HGY/2023/3351: OAK LAWN, COMPTON AVENUE, HIGHGATE

Comparisons of heights of ridge and eaves from ground level over time:

Dwg. No. 1202 S 05

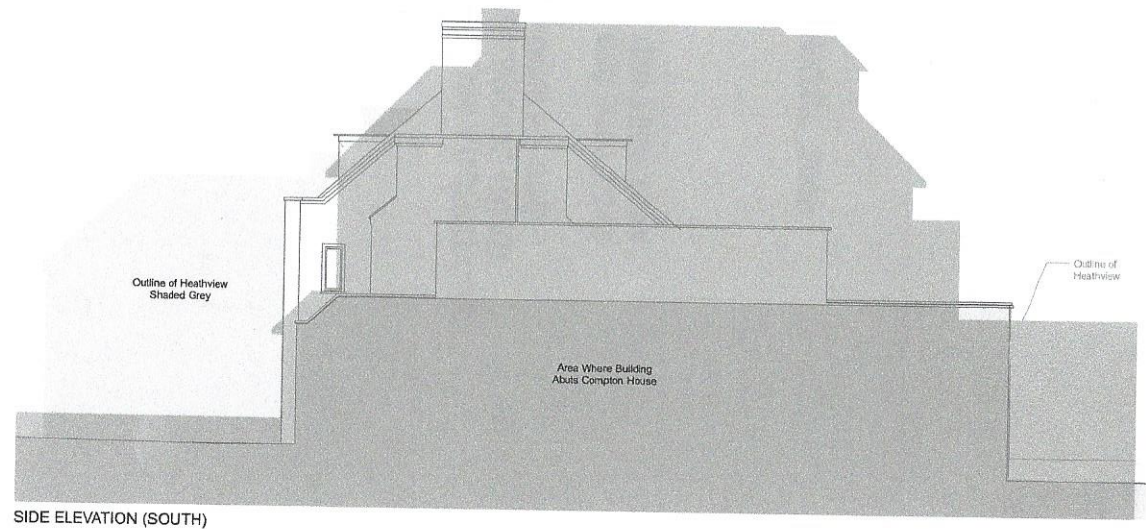
1 As existing:

Ground level to ridge:	10,500 mm				
Ground level to eaves:	5,500 mm				
Eaves to ridge:	5,000 mm	Existing roof is approx same height as GL to eaves			
Ground level to eaves as percentage of height					52.40%
Eaves to roof as a percentage of height					47.60%

Orig. No. 1202 AP 05A

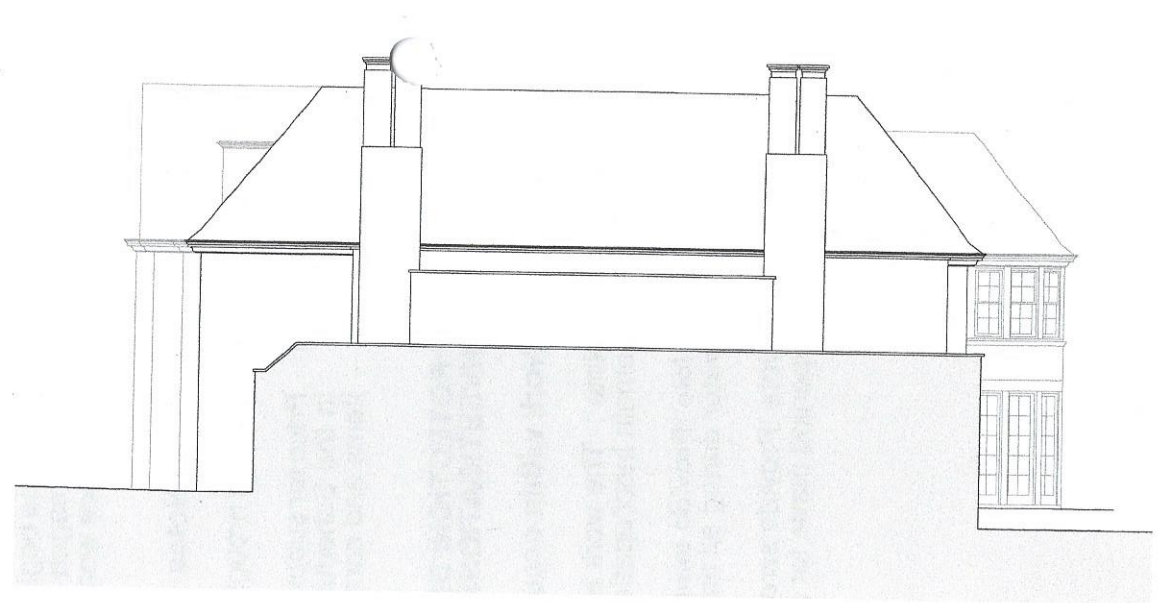
2 HGY/2016/1930 consent

Ground level to ridge:	11,020 mm	Dim provided			
Ground level to eaves:	6,500 mm				
Eaves to ridge:	4,520 mm				
Ground level to eaves as percentage of height					59%
Eaves to roof as a percentage of height					41%

Project Number	Drawing Number	Revision
23002	PL_200

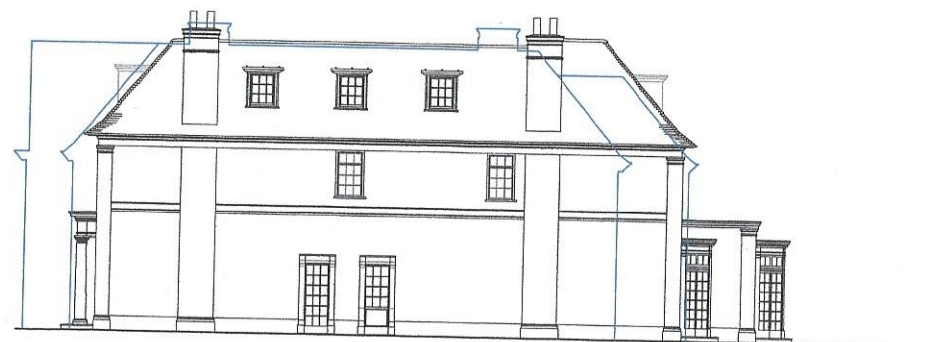
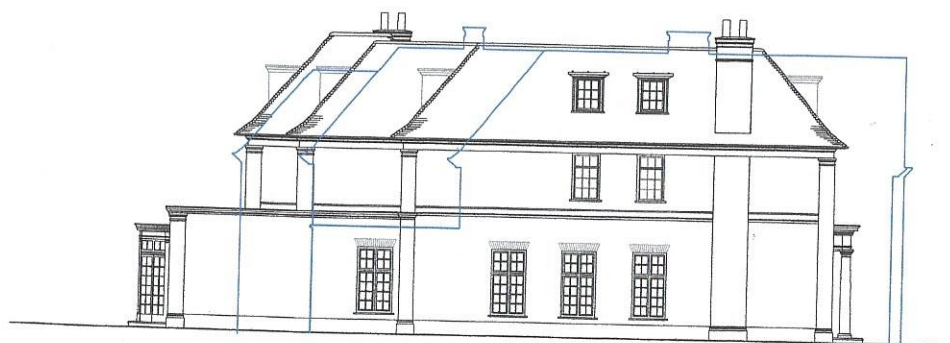
3 HGY/2023/3351 application

Ground level to ridge:	11,300 mm				
Ground level to eaves:	7,500 mm	Main eaves level			
Eaves to ridge:	3,800 mm	Main eaves level			
	11,300 mm				
Ground level to eaves as percentage of height					66%
Eaves to roof as a percentage of height					34%
Ground level to eaves :	8,000 mm	Central section of main elevation			
Eaves to ridge:	3,300 mm	Central section of main elevation			
	11,300 mm				
Ground level to eaves as percentage of height					70.8%
Eaves to roof as a percentage of height					29.2%
